RE: M-2013-2364201, I-2015-2472242

Bridge structure where State Route 1025, crosses over: a single track of Canadian Pacific Railroad (264 293 : K) in Nicholson Borough, Wyoming County :	M-2013-2364201 Electronically Filed
Investigation upon the Commission’s own : motion to determine the condition and disposition : of six (6) existing structures carrying various : highways above the grade of the tracks of the : Canadian Pacific Railroad in Great Bend Township, : New Milford Township, Brooklyn Township, Hop : Bottom Borough, Lathrop Township, Susquehanna : County and Benton Township, Lackawanna County :	I-2015-2472242 Electronically Filed

**COMMONWEALTH OF PENNSYLVANIA, DEPARTMENT OF
TRANSPORTATION’S COMMENTS AND OBJECTIONS TO THE FINAL REPAIR
PLANS FOR S.R. 1025, S.R. 2032, AND S.R. 2041**

PROPOSED PARAPET WALL DETAIL

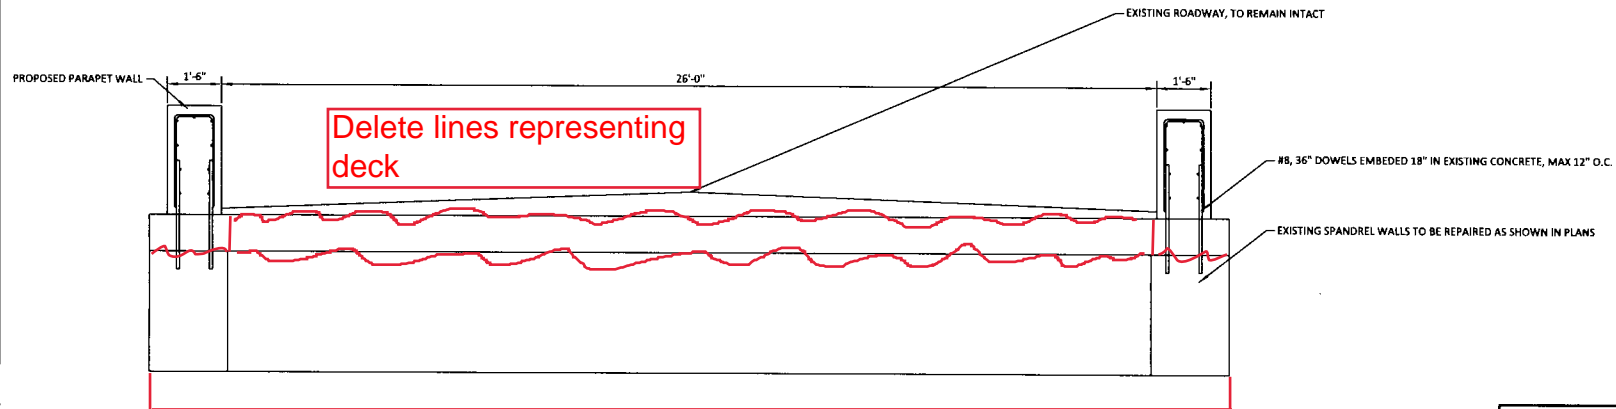
- b) Refer to S.R. 1025 Plan Set Sheet 10 of 10. Change the title of the “Existing Plan” detail to read “Existing Typical Section”. Also, this detail shows what can be interpreted as a concrete deck below the wearing surface and under the proposed barriers. We have no plans indicating a deck is present above the spandrel walls. Revise this detail to show the proposed barrier on top of the existing spandrel wall and remove the lines representing the “deck” from the detail. The arch ring should be added under the spandrel walls across the entire section. See markup attached as Exhibit C. Consider constructing a vertical wall barrier integral with a moment slab that sits on top of the repaired spandrel walls in order to provide a crash worthy, properly anchored bridge barrier; the proposed details on Sheet 10 of 10 do not follow PennDOT standard drawings for bridge barrier. See attached BD-627, which is attached as Exhibit D, showing the moment slab/barrier details.

Delete lines representing deck

Add lines to represent arch

Existing Typical Section
